Dominion Nuclear Connecticut, Inc.
Millstone Power Station
Rope Ferry Road
Waterford, CT 06385

B18415

Millstone Nuclear Power Station, Unit Nos. 1, 2 and 3
Technical Specification Change Request
Administrative and Editorial Changes to the Unit Nos. 1, 2 and 3
Technical Specifications

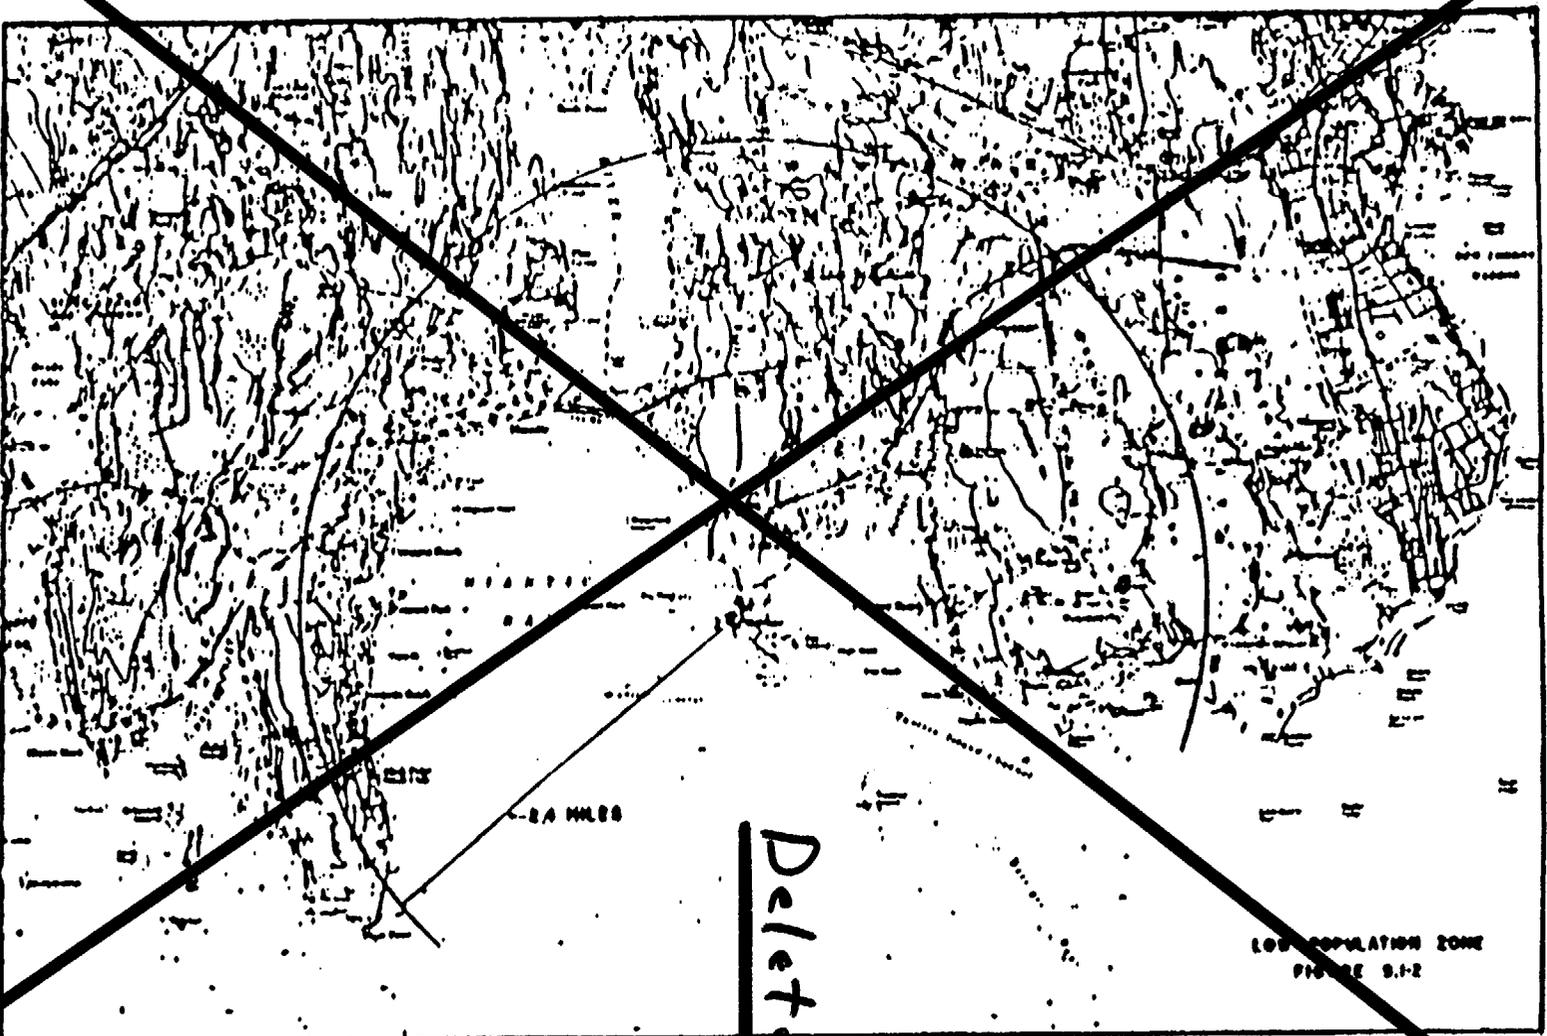
Delete Specification 5.1.2 and corresponding Figure 5.1-2, both named "Low Population Zone" (LPZ) and replace them with Specification 5.1, "Site Location." Unit Nos. 2 and 3 TS Figures 5.1-2 contain information corresponding to a textual description of the LPZ included in Section 2.1.3.4, "Low Population Zone," of the Unit No. 3 FSAR which is referenced by Section 2.1, "General Description," of the Unit No. 2 FSAR.

Figure 5.1-2 depicts the LPZ as a circle centered on the respective reactor having a 3860 meter (approximately 2.4 statute mile) radius. Removal of Specification 5.1.2 and associated Figure 5.1-2 is acceptable as this information does not meet any of the inclusion criteria for information required to be contained in the TS pursuant to 10 CFR 50.36(c)(4). The NRC has previously found it acceptable to remove figures describing the LPZ from the TS.⁽⁷⁾ This proposed change is consistent with the guidance provided in the appropriate improved STS NUREG, i.e., NUREG-1432 for Unit No. 2 and NUREG-1431 for Unit No. 3, which do not include an LPZ specification. A description of the LPZ is included in Section 2.1.3.4 of the Unit No. 3 FSAR which is referenced by Section 2.1 of the Unit No. 2 FSAR. The existence of this discussion within the Unit No. 3 FSAR (which is referenced by the Unit No. 2 FSAR) will ensure that any change to the LPZ will be evaluated under the 10 CFR 50.59 process.

Delete

FIGURE 5.1-1 EXCLUSION AREA

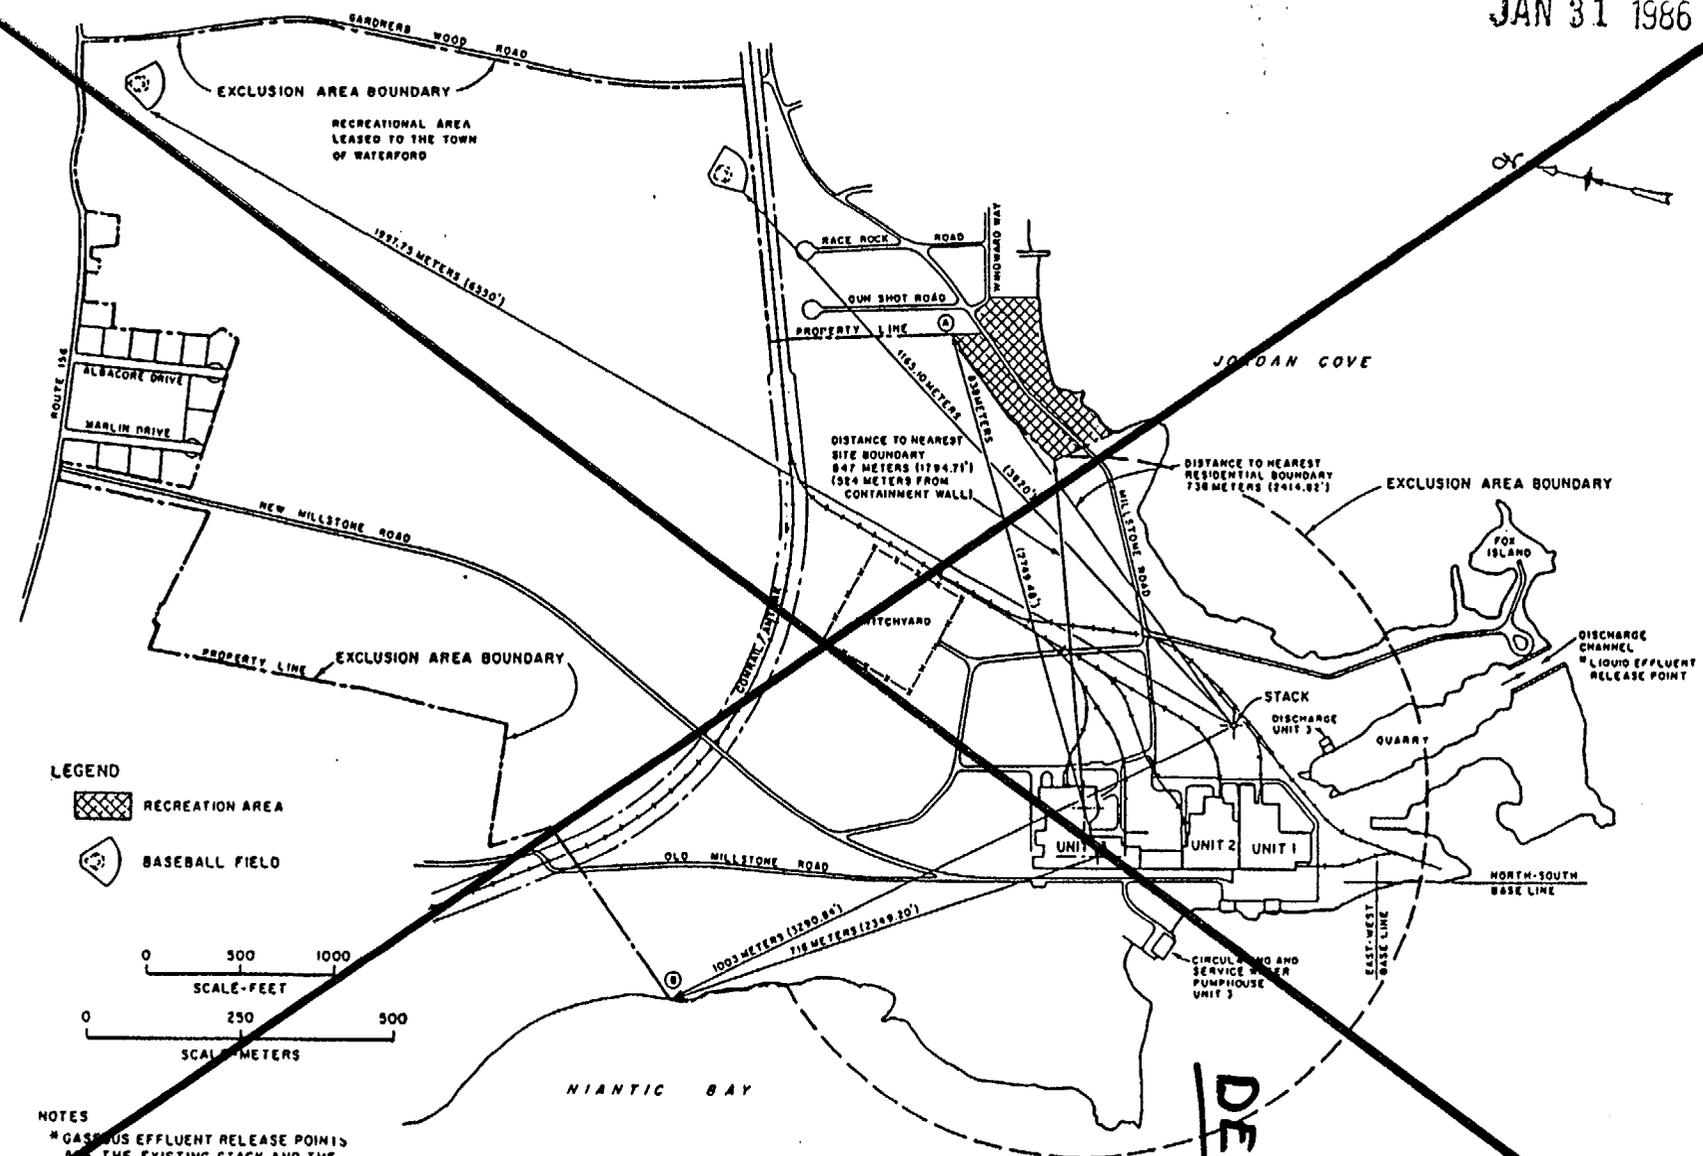
Delete Specification 5.1.1 and corresponding Figure 5.1-1, both named "Exclusion Area," and replace them with Specification 5.1, "Site Location." Unit No. 3 FSAR Section 2.1.1.3, "Boundaries for Establishing Effluent Release Limits," discusses the EAB for the site. Since each unit has several radioactive effluent release points, Unit No. 2 FSAR Table 2.3-1 provides the distances (for each sector) for Unit 2 and Unit No. 3 FSAR Table 2.3-34 provides the distances (for each sector) for Unit No. 3 for the distance from each release point to the EAB. Unit Nos. 2 and 3 FSAR Sections 2.3.4, "Short-Term (Accident) Diffusion Estimates," describes the application of the methodology. Unit No. 2 TS Figure 5.1-1 is equivalent to, and Unit No. 3 TS Figure 5.1-1 corresponds to, Unit No. 3 FSAR Figure 2.1-3. The Unit No. 2 FSAR, Section 2.1, "General Description," references the Unit No. 3 FSAR Figure 2.1-3 for the EAB over land and describes in words the EAB over water for the different release points.

The guidance of NUREG-1431 and 1432 recommends inclusion of a text-only description of the site location. The NRC Staff has previously found it acceptable⁽⁷⁾ to remove figures describing the EAB provided that the text description contains adequate information pertaining to the site boundary and location. The description of the site location provided in Specification 5.1 contains equivalent information to that provided in TS Figure 5.1-1. In accordance with 10 CFR 100, the site description includes a minimum distance to the EAB to ensure that the area, for which the licensee has the authority to determine all activities including the exclusion or removal of personnel and property from the area, is clearly associated with the "place of use" referred to in Section 182.a of the Atomic Energy Act. The inclusion of this map in the Unit No. 3 FSAR, which is referenced by the other Millstone unit's, will ensure that any change to either the boundary or the zone will have to be evaluated under the 10 CFR 50.59 process.

FIGURE 5.1-3 SITE BOUNDARY FOR LIQUID AND GASEOUS EFFLUENTS

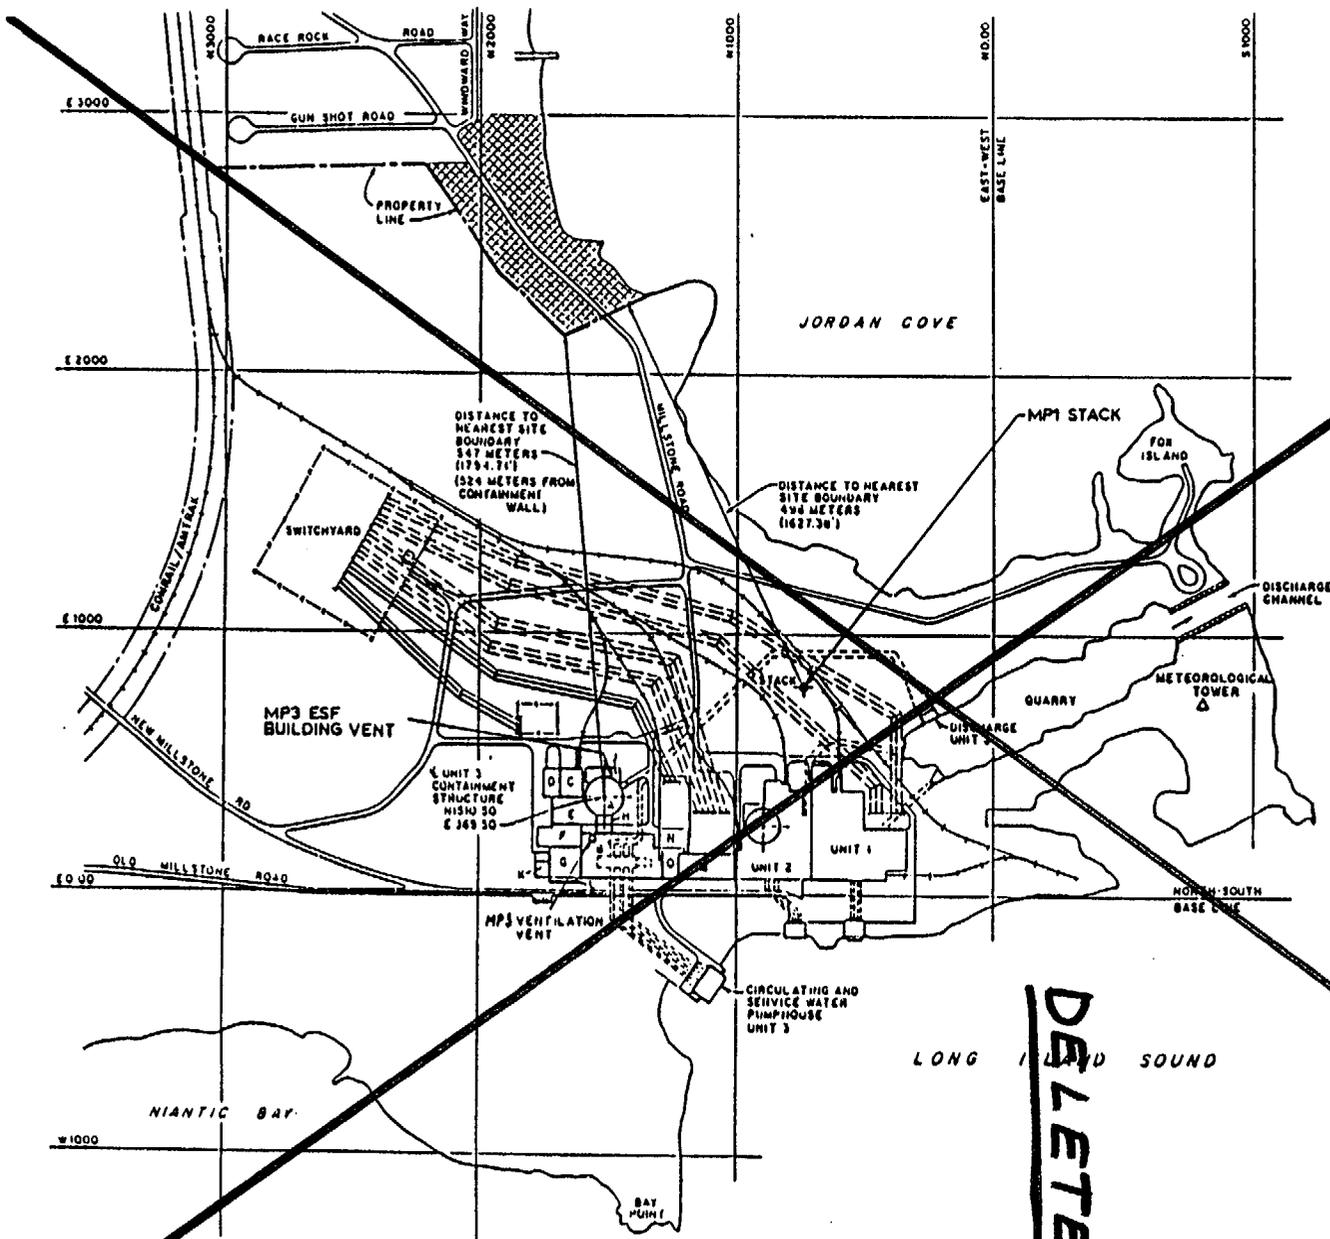
Delete Specification 5.1.3 and corresponding Figure 5.1-3, both named "Site Boundary for Liquid and Gaseous Effluents," and replace them with Specification 5.1, "Site Location." Unit No. 3 TS Figure 5.1-3 corresponds to Unit No. 3 FSAR Figure 2.1-3.

Unit No. 3 TS Figure 5.1-3 depicts the site boundary for liquid and gaseous effluents. Removal of Specification 5.1.3 and associated Figure 5.1-3 is acceptable as this information does not meet any of the inclusion criteria for information contained in TS pursuant to 10 CFR 50.36(c)(4). The NRC has previously found it acceptable to remove figures describing the EAB and LPZ from the TS and removing the figure describing the site boundary for liquid and gaseous effluents is similar in concept. This proposed change is consistent with the guidance provided in the improved STS NUREG-1431⁽²⁾ which does not include a specification for the site boundary for liquid and gaseous effluents. A description of the site boundary for liquid and gaseous effluents is included in Section 2.1.1.3, "Boundaries for Establishing Effluent Release Limits," of the Unit No. 3 FSAR. The existence of this discussion and the associated figure within the Unit No. 3 FSAR will ensure that any change to the site boundary for liquid and gaseous effluents will be evaluated under the 10 CFR 50.59 process.

Delete Unit No. 2 Specification 5.8 and Unit No. 3 Specification 5.5, "Meteorological Tower Location," from the respective TS. Also, the following figures which show the meteorological tower location, i.e., Figure 5.1-1, "Exclusion Area," for Unit No. 2 and Figure 5.1-3, "Site Boundary For Liquid And Gaseous Effluents," for Unit No. 3 are proposed to be removed. These
